## APPEAL SUMMARY

**Status:** Decision Rendered**Appeal ID:** 15833**Project Address:** 817 SW 17th Ave**Hearing Date:** 9/13/17**Appellant Name:** Michelle Schulz**Case No.:** B-016**Appellant Phone:** 503-548-2379**Appeal Type:** Building**Plans Examiner/Inspector:** Kathy Aulwes**Project Type:** commercial**Stories:** 9 **Occupancy:** B, M, A **Construction Type:** 1-B**Building/Business Name:** Press Blocks - Half Block Office**Fire Sprinklers:** Yes - Throughout**Appeal Involves:** Erection of a new structure**LUR or Permit Application No.:** 17-182179-CO**Plan Submitted Option:** pdf [File 1] [File 2] [File 3]**Proposed use:** Office with ground level retail

Opening Protectives  
Appeal

REFLECTED CEILING  
PLAN - LEVEL 06 & 07

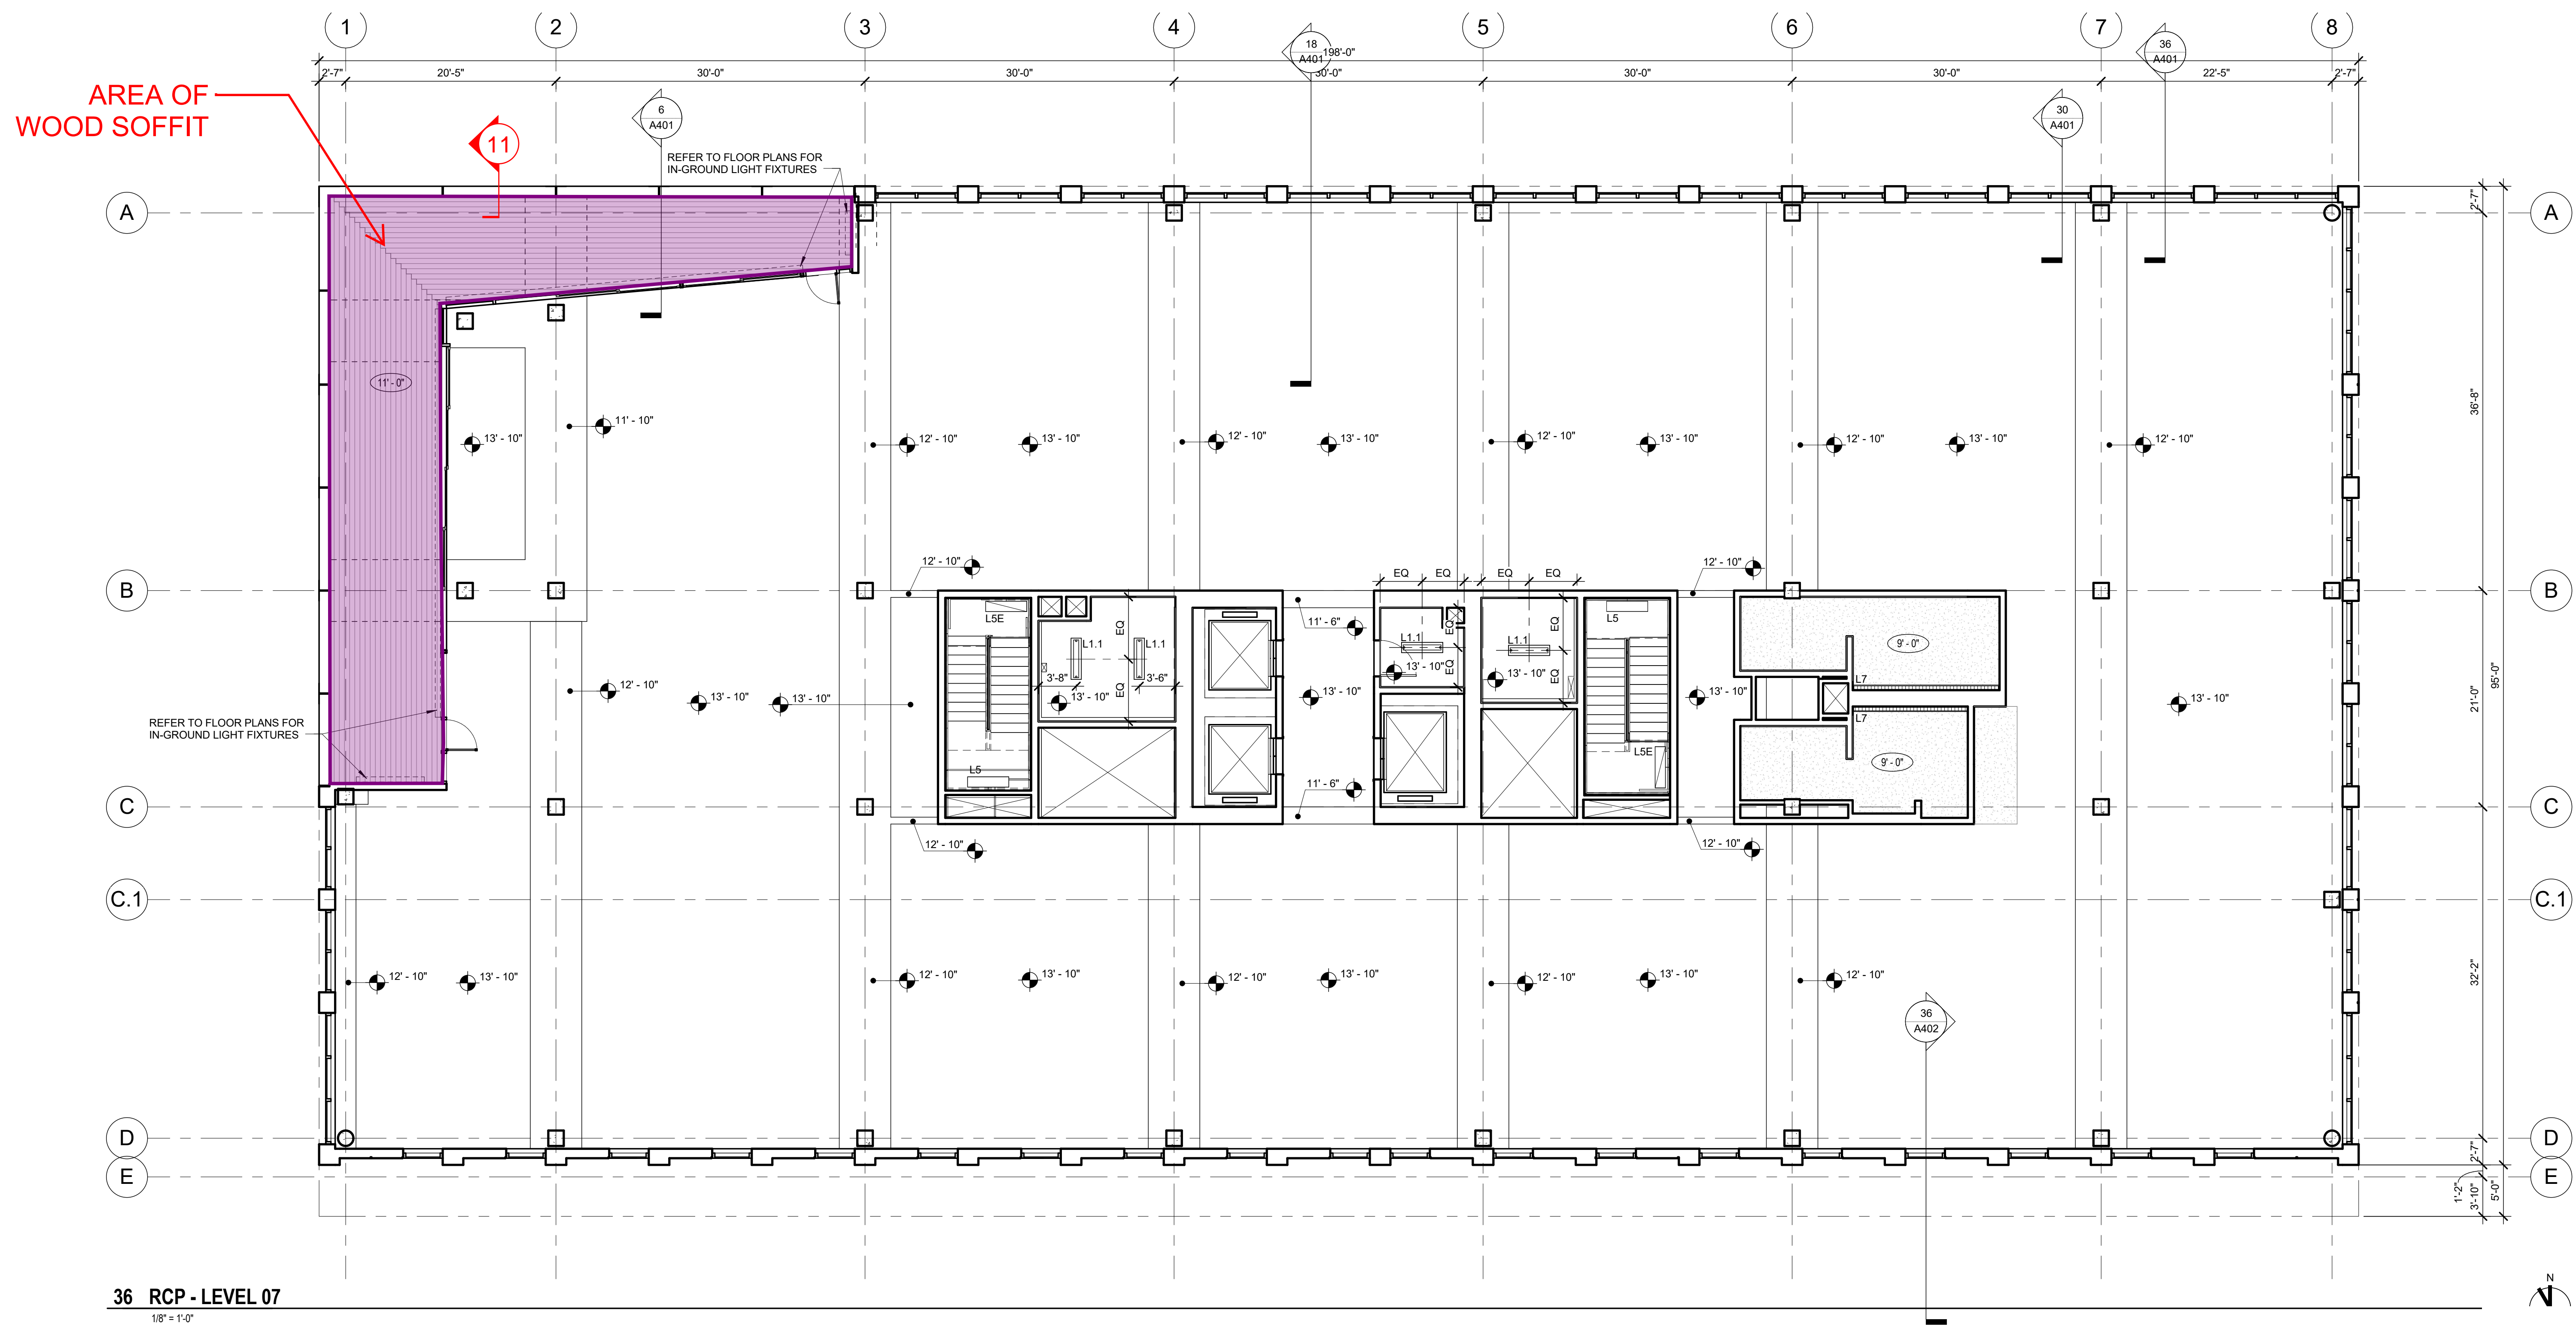
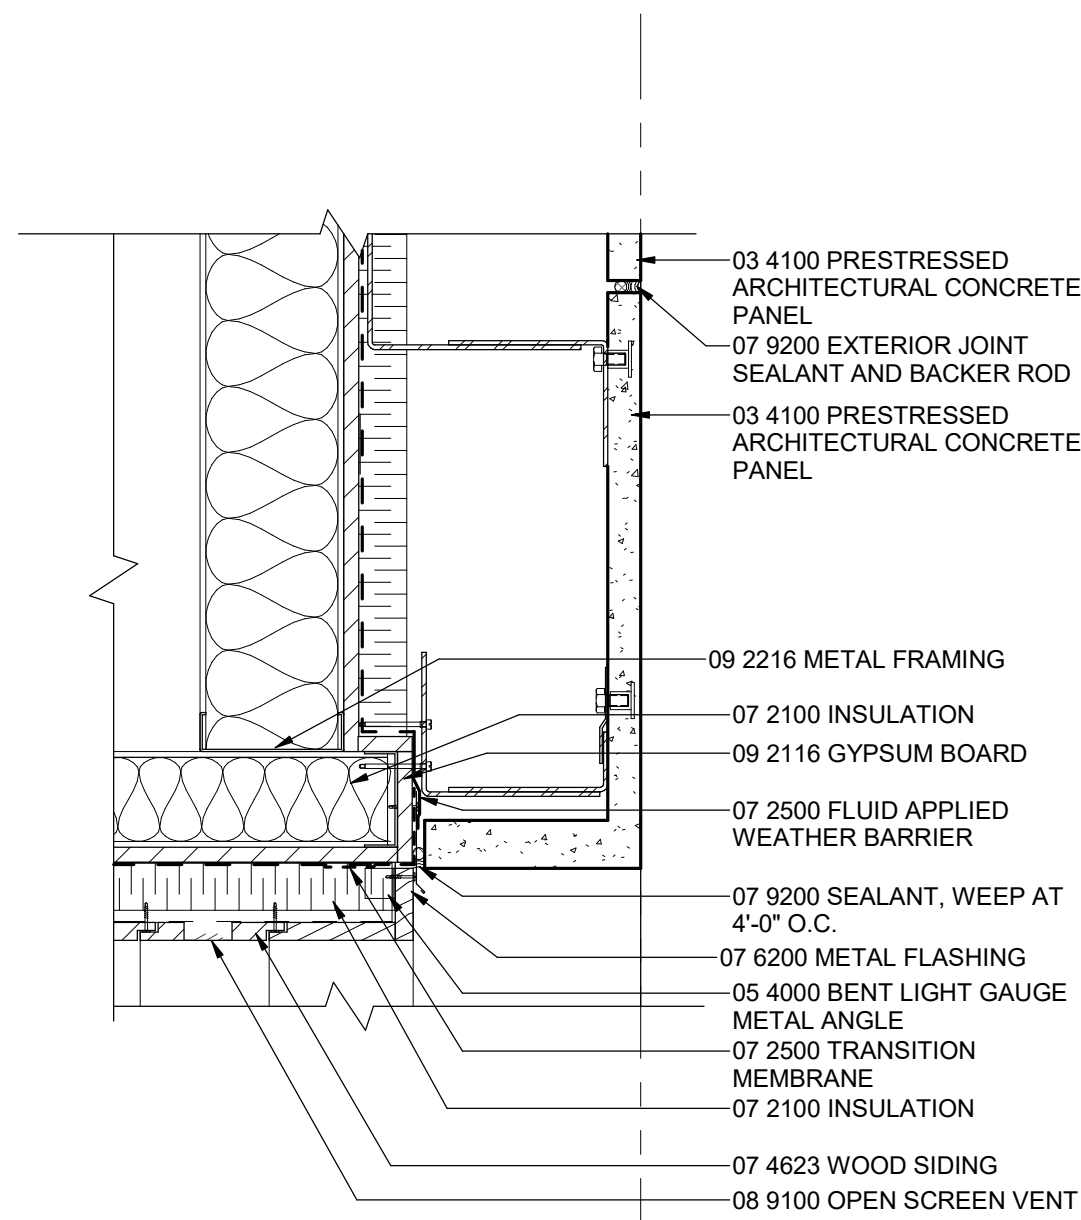
Overhangs located at the ground level and Level 07 are designed using a tropical hardwood material, Cumaru, attached to a non-combustible supporting steel frame which is in turn attached to concrete structural slab.

The primary framing which holds the canopy in place is concrete and the furring is light gauge steel and is non-combustible, so the structural assembly meets the criteria set forth in the OSSC. And the tropical hardwood holds a Class A fire rating and has a flame spread index of not more than 25.

**4. Cumaru tropical wood Class A wood soffit at ground floor and exterior 7th floor amenity space: Granted provided open flame devices are located with a minimum of ten feet separation from the wood soffit.**
